STATE HISTORIC PRESERVATION OFFICE (SHPO) QUESTIONS & RESPONSES

Fort Apache Home of Harmony Project

March 13, 2024

This Addendum includes Architect's responses to SHPO questions pursuant to Historic Tax Credit (HTC) grant award. These questions have minor effect on the drawings and were not included in during the bidding process to avoid conflict and/or confusion with addendums that directly related to bidding/pricing. Some of these questions necessitated specific drawing revisions, which were issued with the following narrative responses. These questions and answers, along with revised sheets, are being memorialized as ADDENDUM #9, and affected sheets / Specification Pages are included in the Construction Document Issuance hereafter. While it is not anticipated that these changes have cost implications, the Contractor shall alert the Architect and Owner in the event they do.

1 LOWER LEVEL DEMOLITION FLOOR PLAN
SCALE: 3/16" = 1'-0"

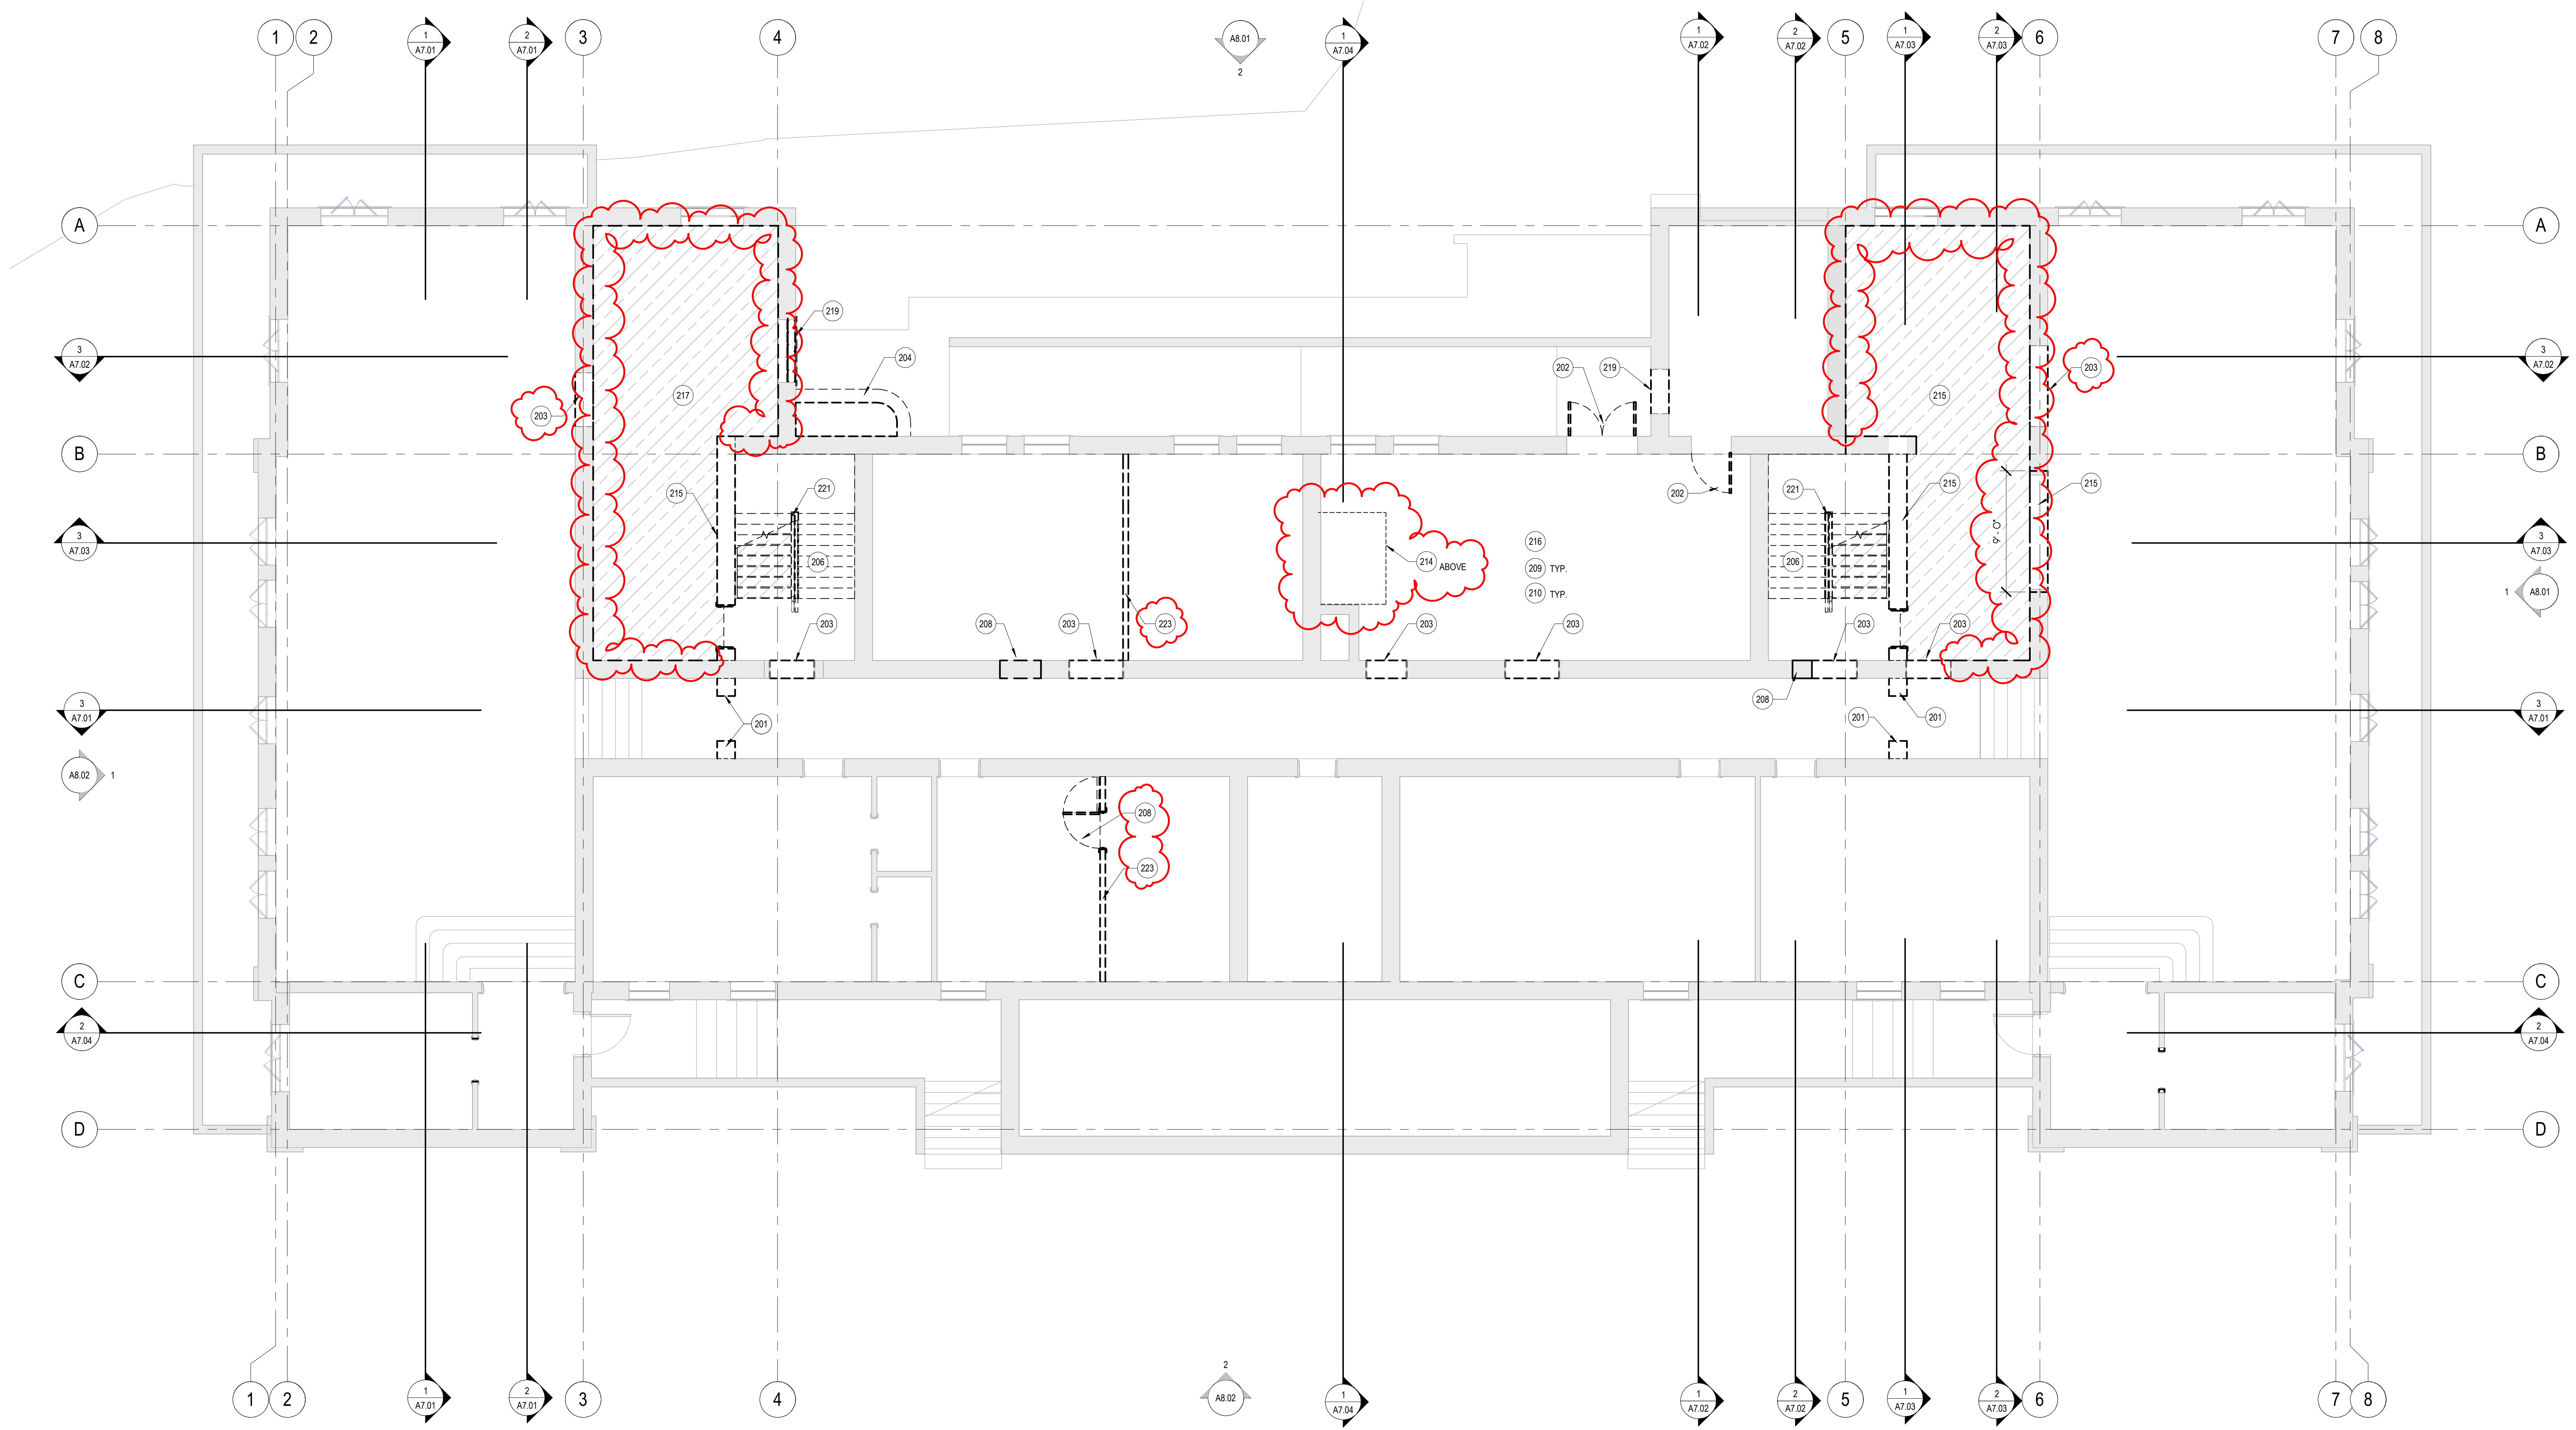
Where removal boundaries are known, please show as dashed lines on drawings. Some demo related keyed notes are generalized but NPS reviewers will want to know extents, graphically.

Additional dashed line boundaries have been added and more-specific keynotes for removal extents to the demolition floor plans.

1 LOWER LEVEL - NOTATION FLOOR PLAN
SCALE: 3/16" = 1'-0"

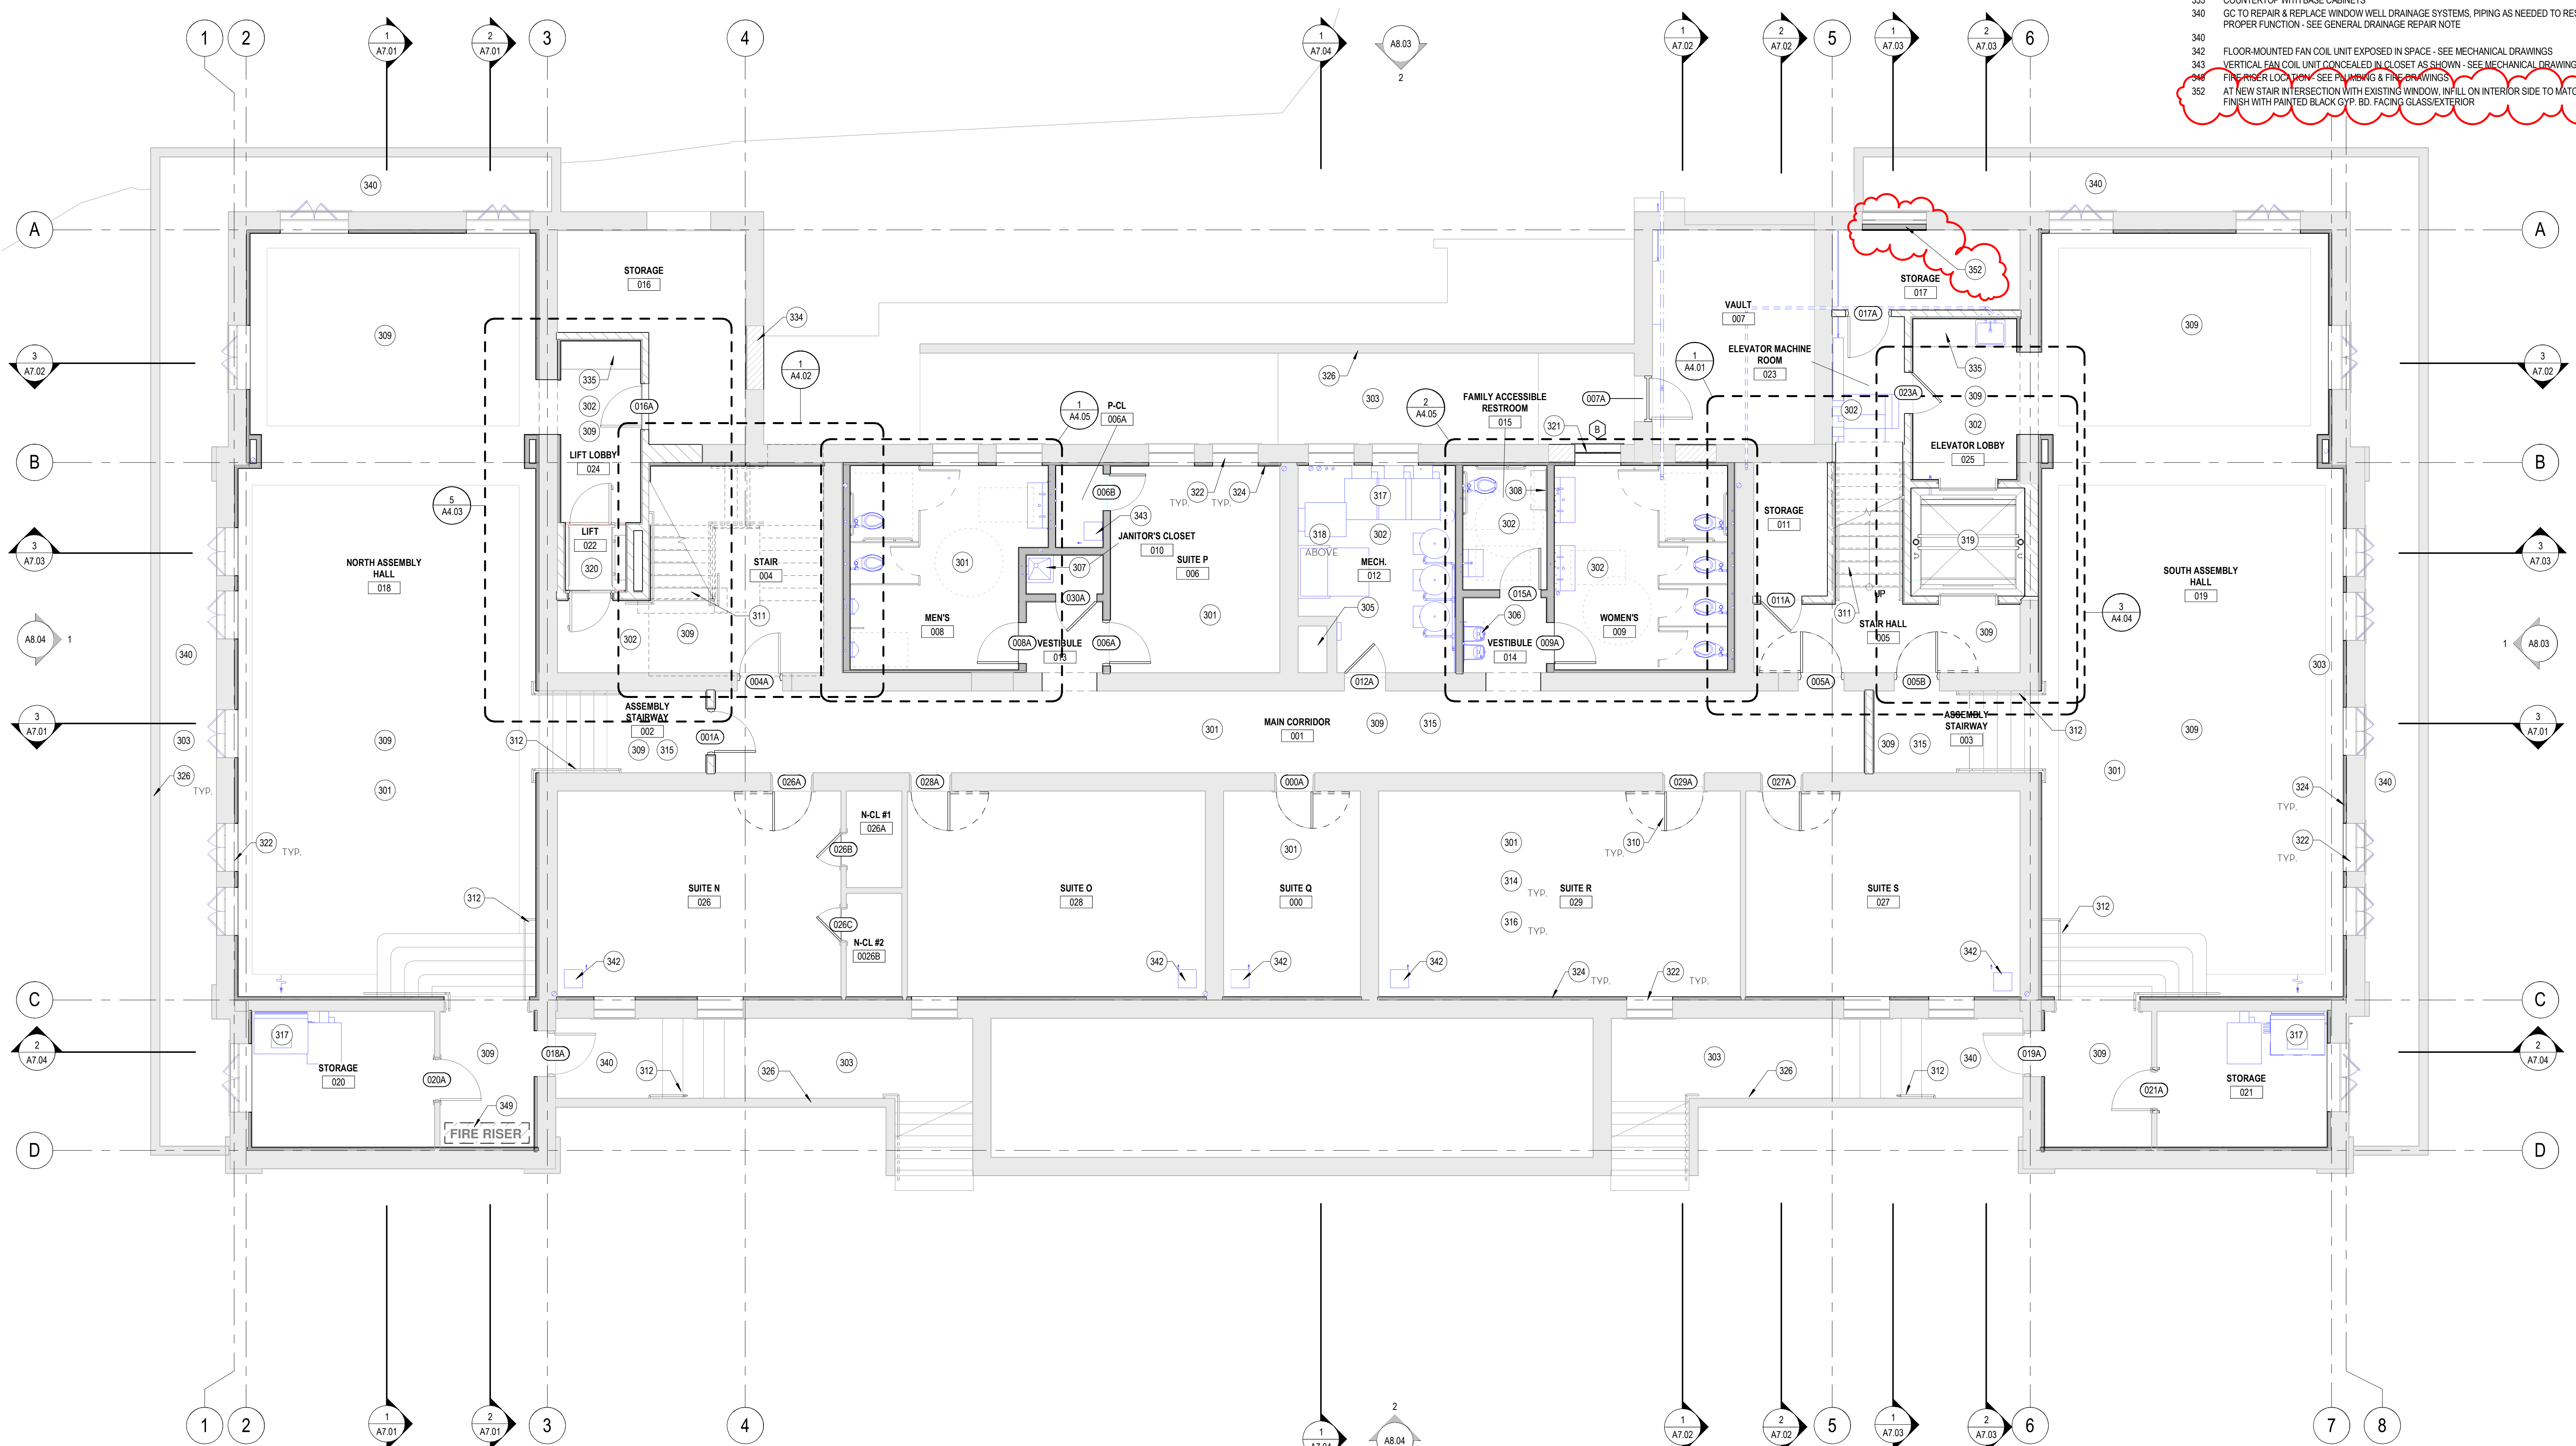
Delete references to "industrial" finish/approach where it may appear in drawings or application. Minimalist is more accurate; this was a dormitory not a factory. "Institutional" would also be acceptable.

On Sheet A3.01, does the new handrail span over the window of Suite N Rm 116?

"Industrial" has been replaced with "Minimalist" in the finish scope legend (sheets A3.01, A3.02, A3.03).

No.
